**Re: Application for Site Plan Review
Assessor's Map 201, Lot 2
960 Sagamore Avenue
Altus Project No. 5079**

On December 7, 2021, the project team met with the Technical Advisory Committee (TAC), who voted to recommend approval with seven (7) stipulations. The stipulations are listed below with the comments on how the comments have been or will be addressed for the approval.

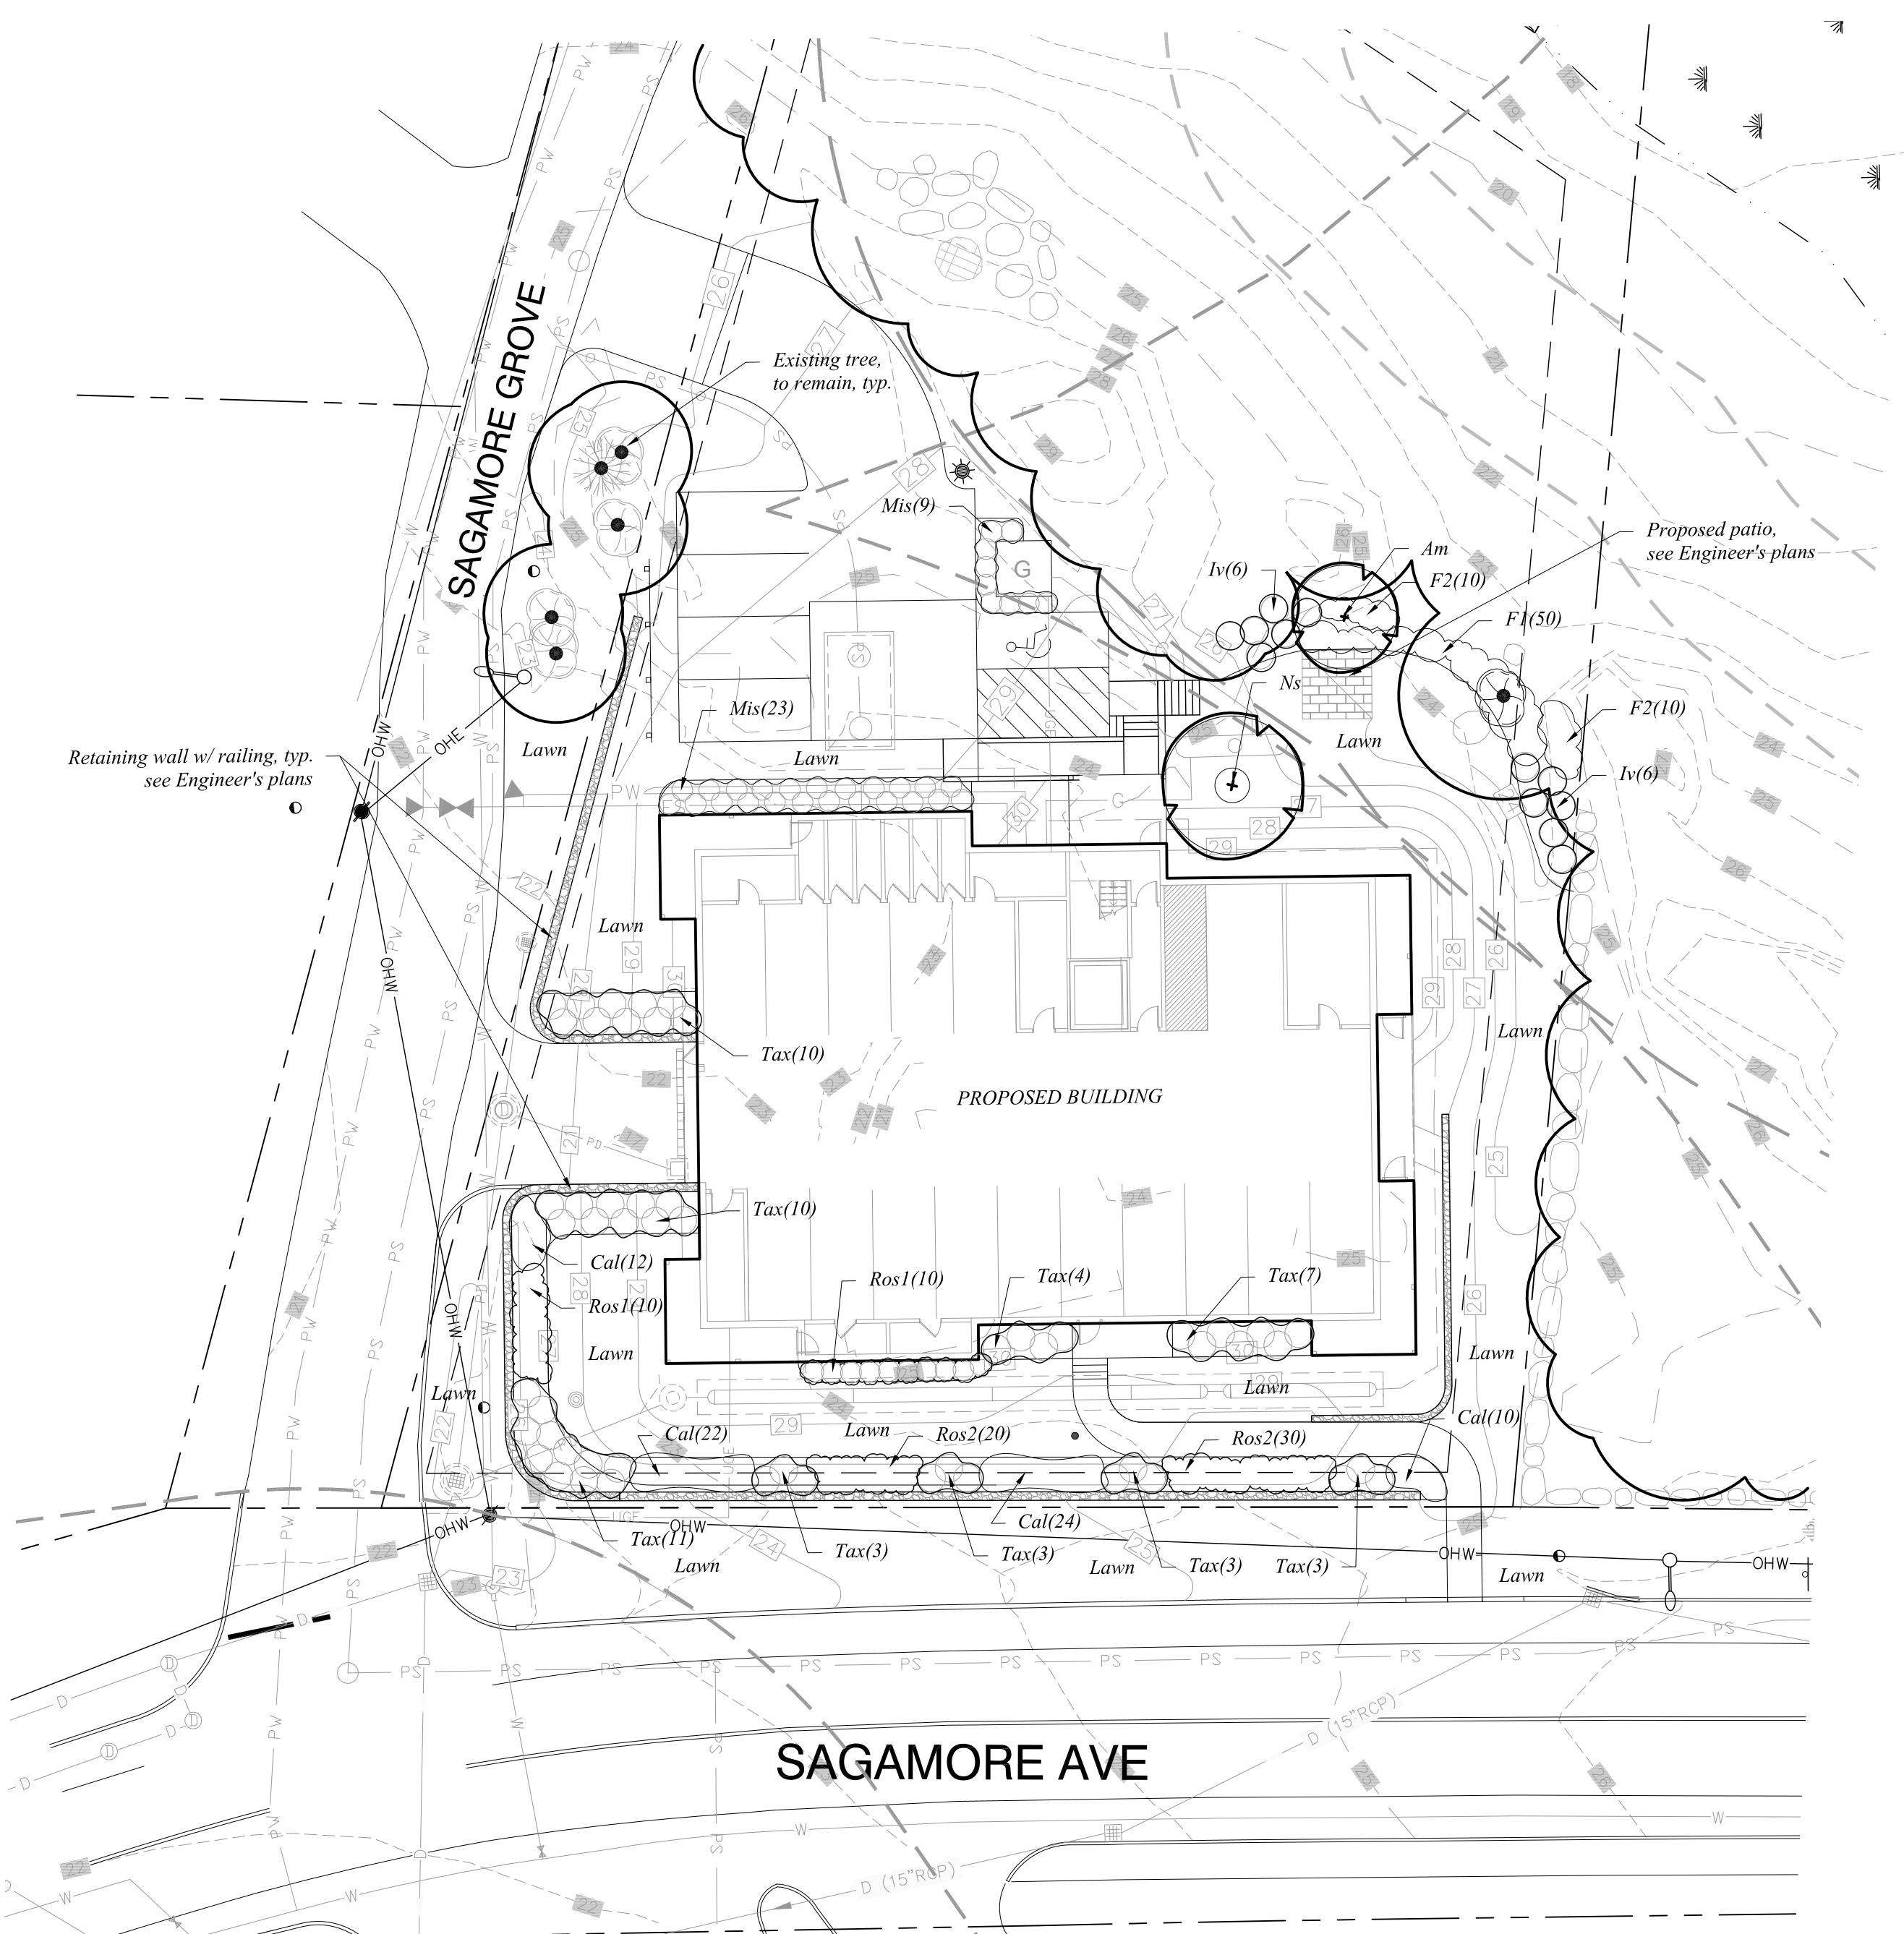
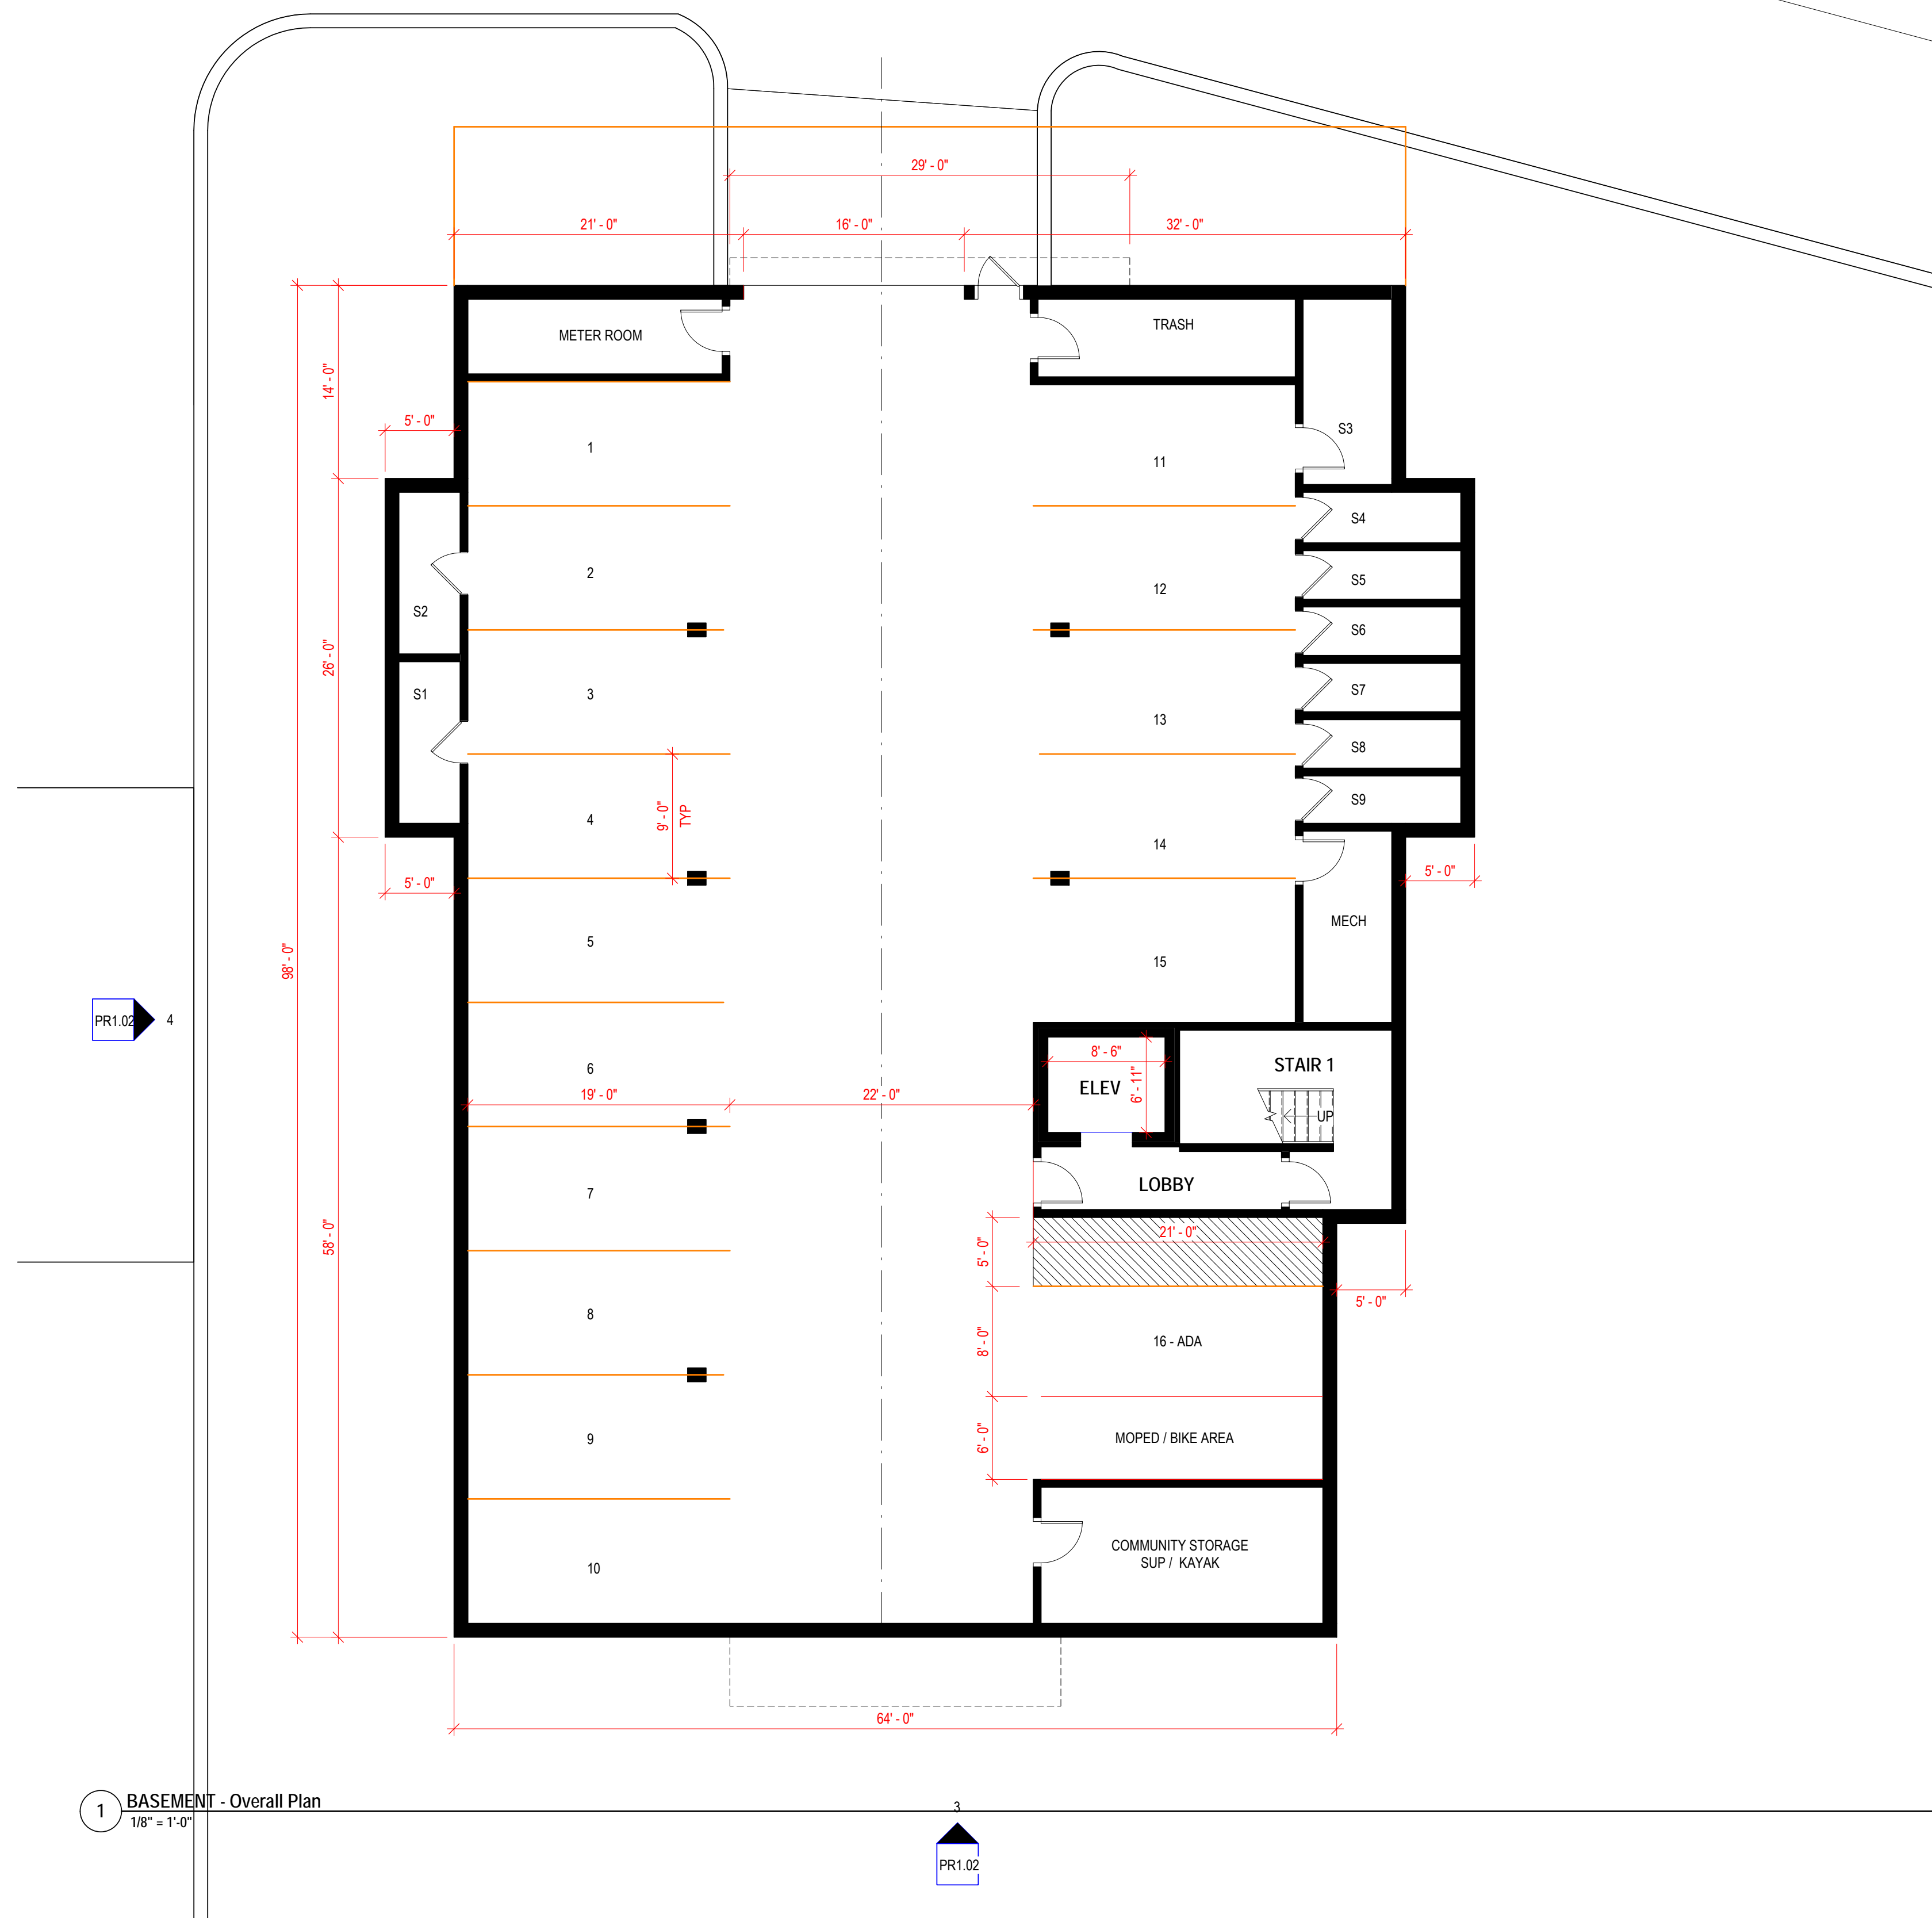
9. *Along the existing stonewall and existing tree line beyond the proposed patio the applicant shall include additional buffer plantings.*

Response: The Landscape Plan (Sheet L-1) has been revised to include additional plantings to provide a native plant buffer, which consists of a combination of ferns as groundcover, Winterberry (12), and one small Amelanchier.
